TODOROSKI
AIR SCIENCES

INDEPENDENT AIR QUALITY REVIEW WESTCONNEX - M4 EAST

NSW Department of Planning & Environment

10 February 2016

Figure 5-1: Observed and modelled mean concentrations of tracer gas (vertical axis) as a function of distance from the road (horizontal axis)

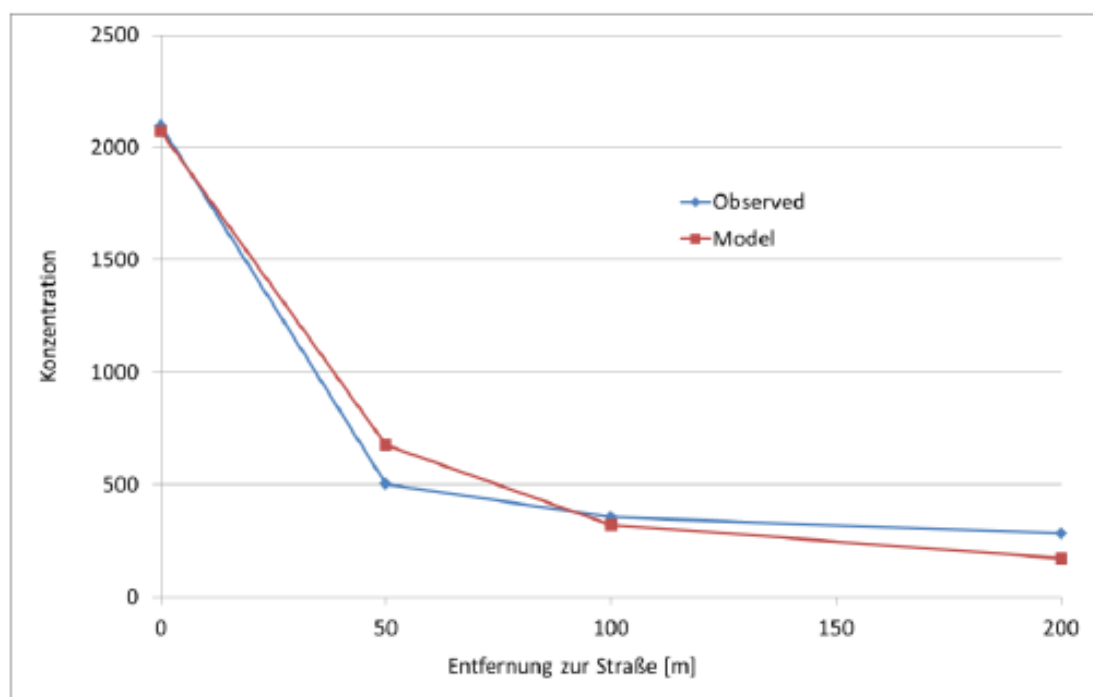
For the Highway 99 data collected in 1984, GRAL had a relatively higher NMSE than other models (apart from CALINE) and no fractional bias. GRAL overestimates low concentrations and underestimates high concentrations, as shown in **Figure 5-1** which presents a plot, showing the observed and modelled mean concentrations of the tracer gas as a function of distance from the road.

Figure 5-2: Quantile-Quantile plot of observed and modelled concentrations (Idaho Falls)

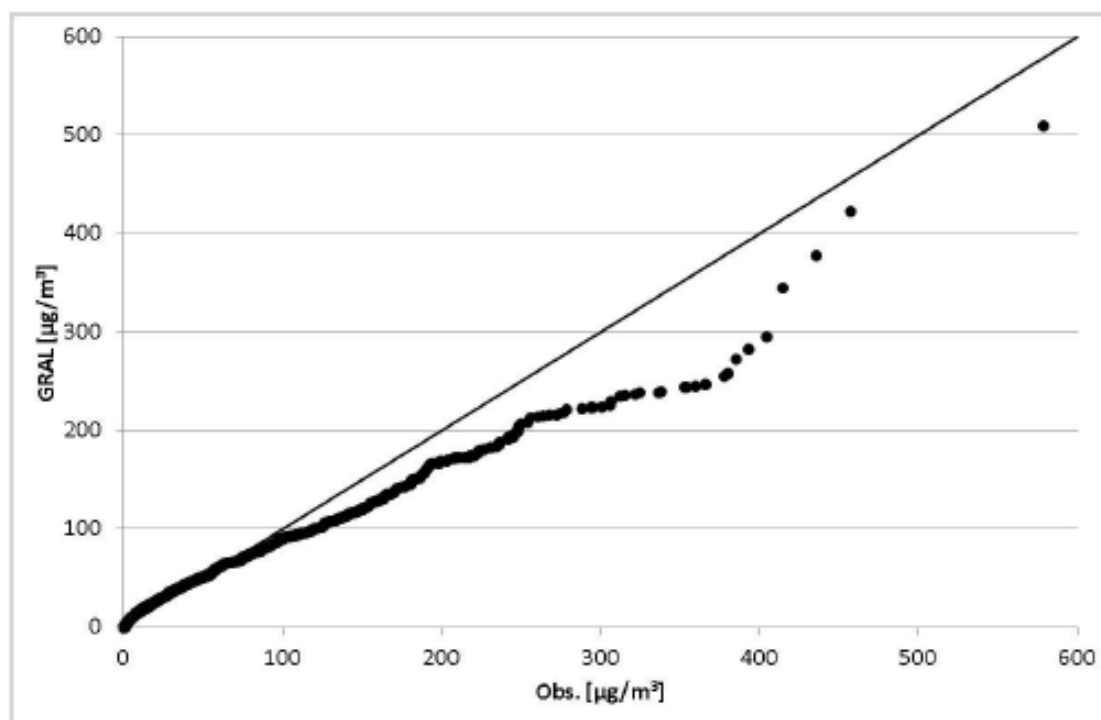
For the Idaho Falls data collected in 2008, GRAL had the largest NMSE, and zero fractional bias. GRAL appears to underestimate almost all of the measured (observed) results, as shown in **Figure 5-2** which presents the Quantile-Quantile plot of observed and modelled concentrations. The location is characterised as having flat terrain with low lying scrub 10 to 30 cm in height.

Figure 5-3: Quantile-Quantile plot of observed and modelled concentrations (Idaho Falls with noise barrier)

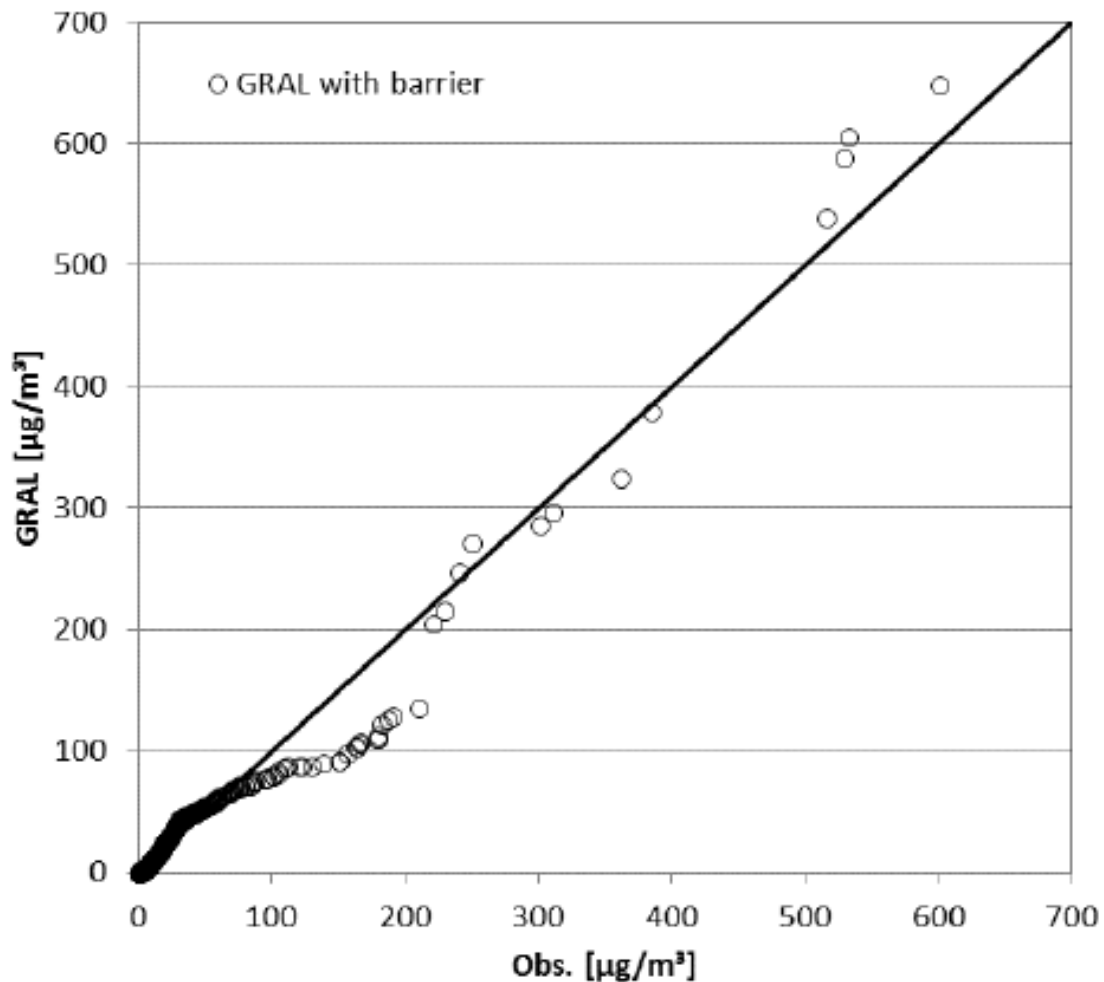
For the Idaho Falls with noise barrier data, only GRAL was evaluated. It had a relatively high NMSE of 3.1, and fractional bias of 0.1. GRAL appears to somewhat overestimate the very highest concentrations, but has some significant underestimation of moderate concentrations, as shown in **Figure 5-3** which presents the Quantile-Quantile plot of observed and modelled concentrations. The experiment has a 6m high and 90m long noise barrier downwind and parallel of the 54m metre long line source from which the tracer gas was released. The two monitors near to but upwind of the noise barrier recorded gas concentrations up to 20 times higher than the downwind monitors. The data from these high reading monitors was excluded in the GRAL model validation.

Figure 5-4: Plot showing predicted (GRAL) vs. measured (MON) average hourly NO_x levels at monitoring location M1

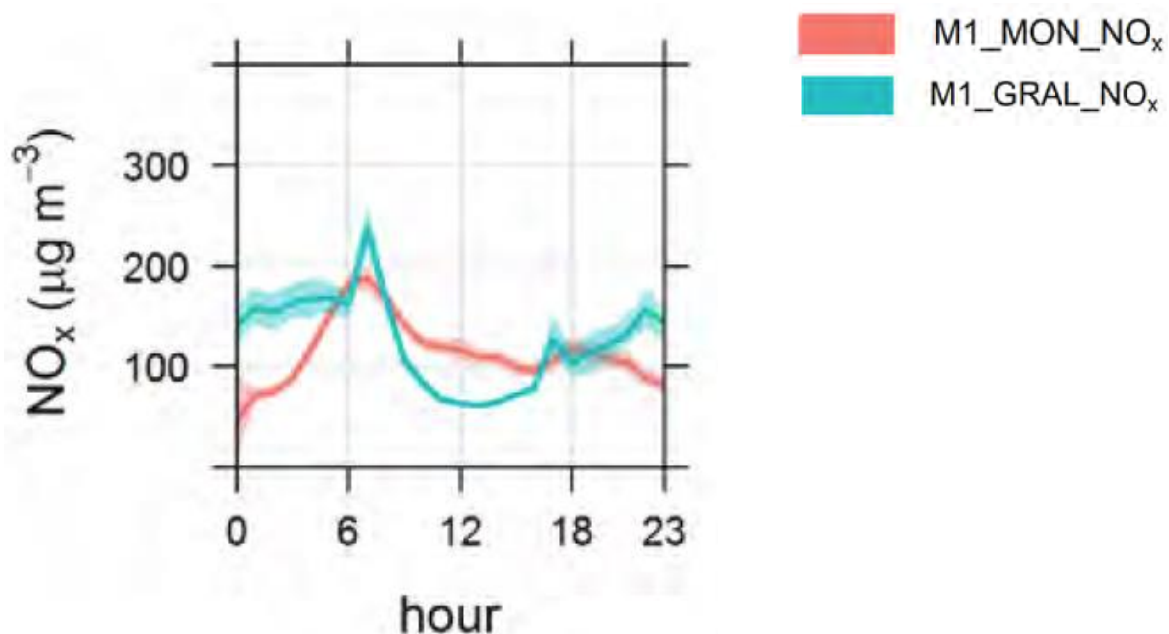
The Proponent compared the GRAL modelled results with the measured data at two roadside monitoring sites and found that GRAL overestimates the (monthly and daily average) measured NO_x road increment at the RMS F1 monitoring station significantly, overestimates the hourly evening and night time levels at the M1 monitoring station, and significantly underestimates the measured levels in the daytime. The average hourly measured and predicted levels at the M1 monitoring station are shown in **Figure 5-4** below, which is part of Figure J-8 of the assessment.

This situation is not ideal as the data from only these two stations appears to be available to verify the model performance for the most important case of roadside impact predictions. It is not clear why Project monitoring data were not available to be used, or sufficient such data gathered for this purpose.

In this regard the Proponent states that *"For the M1 site the concentrations tended to be....underestimated during the middle of the day"*. It would be more accurate to state that the model significantly underestimates the hourly NO_x levels for every hour of the year from 8am to 4pm at this location. It should be noted that the model performed worse on weekdays and better on the weekend than is indicated in the graph, but this may be due to the model using the higher weekday traffic levels to predict the weekend NO_x levels.

Figure 5-5: Average monthly wind speeds from January 2014 to October 2015

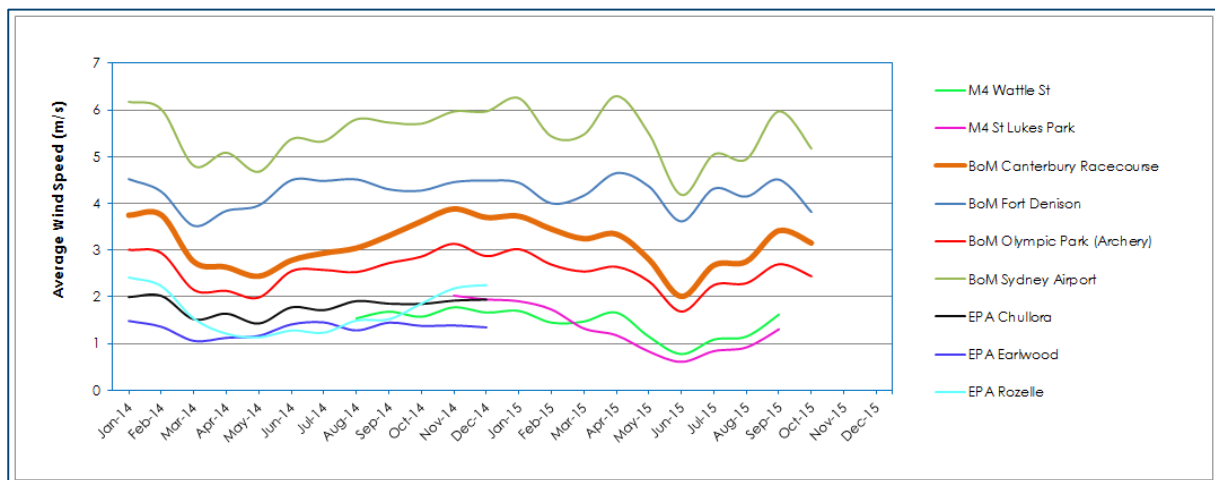
It is noted that most other regulatory approved models would provide perfect (100%) performance results if the same evaluation were done, but the GRAMM model shows inherently limited performance, for example a minimum error of 8% or more for wind speed, and significant bias for higher wind speeds, (see appendix H of the assessment). The proponent conducted regression analysis of only wind speed at several sites. The analysis shows poor model performance except at Canterbury racecourse.

As part of its response, the proponent provided the figure presented below as **Figure 5-5**. The figure shows the proponent's analysis of meteorological data from different BoM, OEH and WestConnex stations comparing average monthly wind speeds recorded at each station from January 2014 to

October 2015. This analysis shows that the meteorological data from the OEH sites have high portions of calm and low wind speeds in contrast to the BoM stations.

The Proponent notes that the data from OEH sites differ to that from BoM sites which may be due to siting and instrument differences. A significant shift in the wind patterns at the OEH sites in later years is observed, and the proponent considers this could be due to changes in the surrounds, instrument replacement and/or sensor alignment problems.

Figure 5-6: Comparison between the stability classes recorded at BoM Canterbury Racecourse and OEH Earlwood

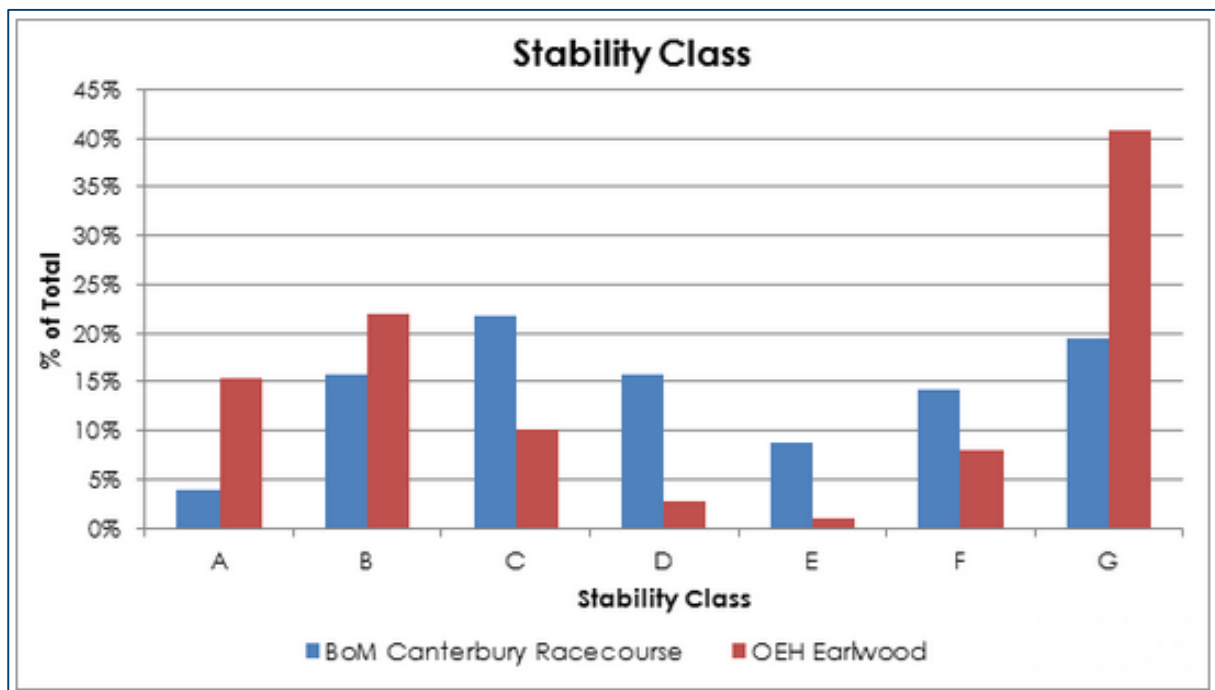
Whilst there are differences in instrumentation, the position/ siting of the weather station, and some differing effects of vegetation etc., as would be expected, the meteorological conditions observed (measured) at the weather stations located across the study area display significant variation (e.g. up to 450% for annual average wind speed).

The proponent made a comparison between the data from the BoM Canterbury Racecourse and OEH Earlwood site and found that the Earlwood data contain a significantly high percentage of calms, low annual average wind speeds and significantly more G class conditions than at Canterbury. **Figure 5-6** presents the Proponent's comparison of the stability classes recorded at BoM Canterbury Racecourse and OEH Earlwood. Stability class is an indicator of atmospheric mixing, with progressively poorer air dispersion occurring under progressively more stable conditions (i.e. from E to G class stability).

The proponent calculated that G class stability conditions would occur for an unusually large fraction of the time annually (>40% at Earlwood and approx. 19% at Canterbury racecourse). This is unusual as such frequent G class stability is generally associated with dry arid inland desserts, and this stability class is not known to occur frequently in urban areas. This is of concern and may potentially be related to the proponent's calculations and quality control checking or the quality of the measured data.

The Proponent notes that the Earlwood station is located in a valley and in a densely populated area which could affect the wind speeds recorded at that location.

Figure 5-7: Annual mean $PM_{2.5}$ concentrations at RWR receptors - for different meteorological data inputs

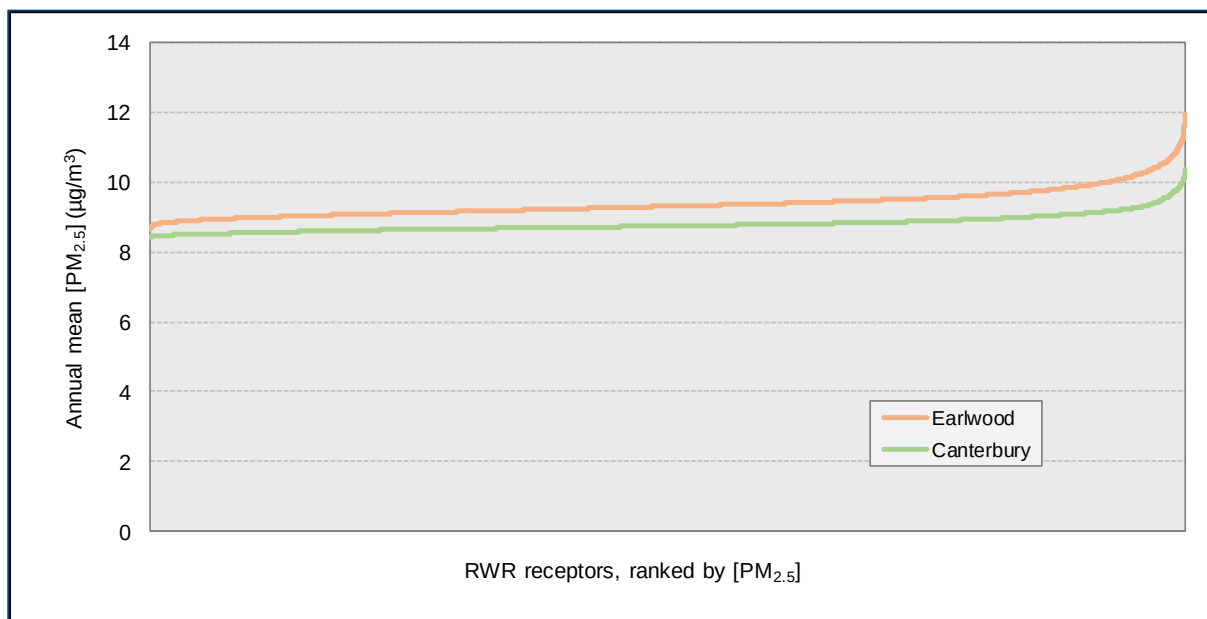
Examination of **Figure 5-7**, when considering that an arbitrary background level of 8µg/m³ has been added to both sets of results, indicates that the modelled results for the traffic emission increase by approximately 40% due to the use of lower wind speed meteorological data inputs.

The Proponent assessed the influence of the meteorological data on the predicted pollutant levels by re-running the model using meteorological data from the OEH Earlwood station.

The analysis shows that modelling with the lower wind speed meteorological data from Earlwood results in higher predicted annual average $PM_{2.5}$ across all RWR receptors compared to the use of BoM Canterbury Racecourse data (see **Figure 5-7**). Modelling with the Earlwood data also resulted in larger changes (both increases and decreases) in the annual average $PM_{2.5}$ due to the Project (see **Figure 5-8**).

Figure 5-8: Relative change in the annual mean PM_{2.5} - for different meteorological data inputs

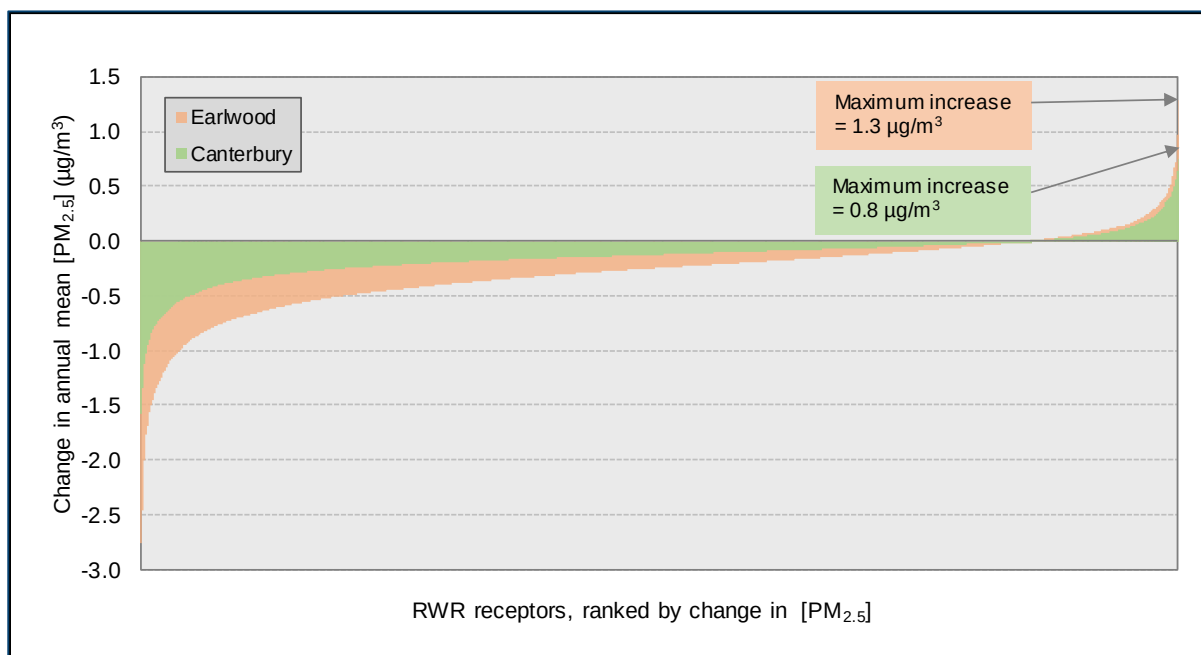
However examination of **Figure 5-8** indicates that the maximum relative increase in road traffic effects at any location is relatively small.

As the background levels are significantly higher than the change that may occur, even if the relative change in absolute terms may vary by 40% due to the use of the OEH Earlwood data, this change remains small and does not change the overall conclusions in the assessment for annual average PM_{2.5}.

Figure 5-10: Changes in predicted annual $PM_{2.5}$ due to varying land use

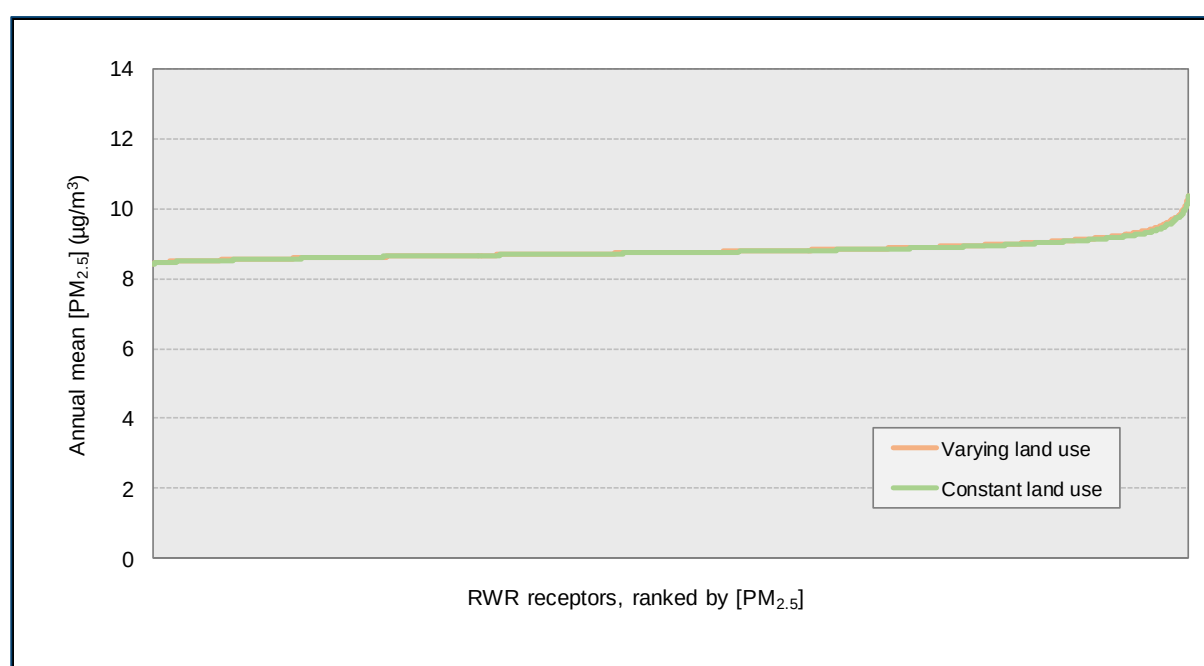
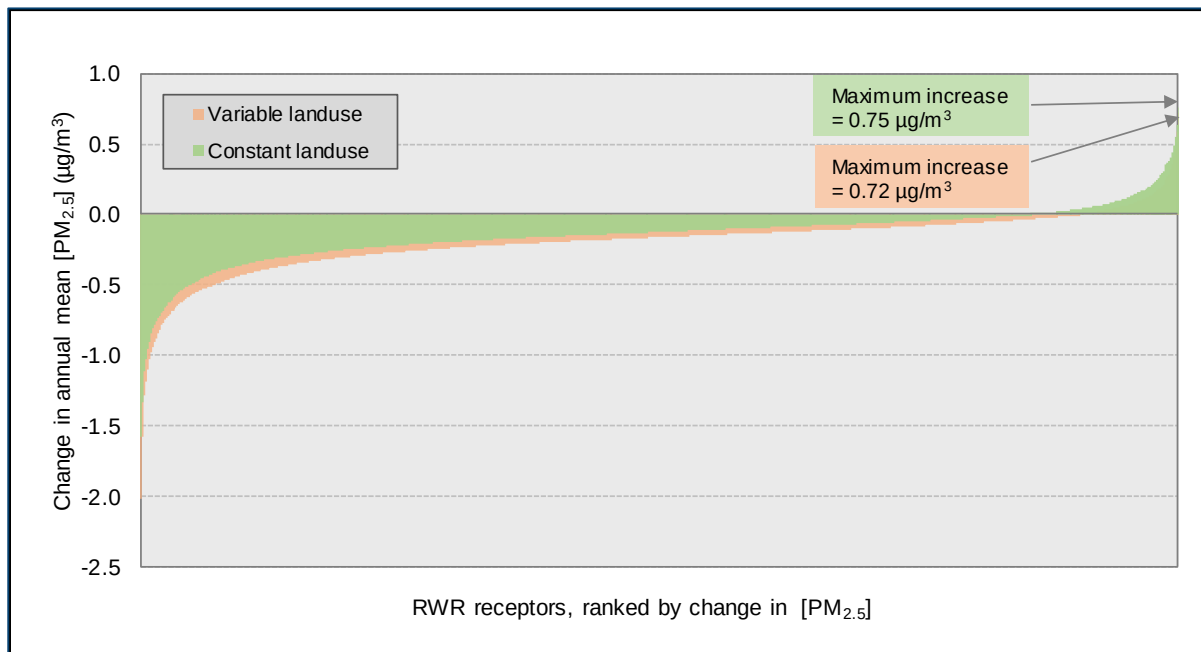
This suggests the use of a varying land use file has little influence in the performance of the model.

The Proponent showed that there is no significant difference between the predicted annual mean PM_{2.5} results across the domain if a varying land use file is used or not used (see **Figure 5-9** and **Figure 5-10**).
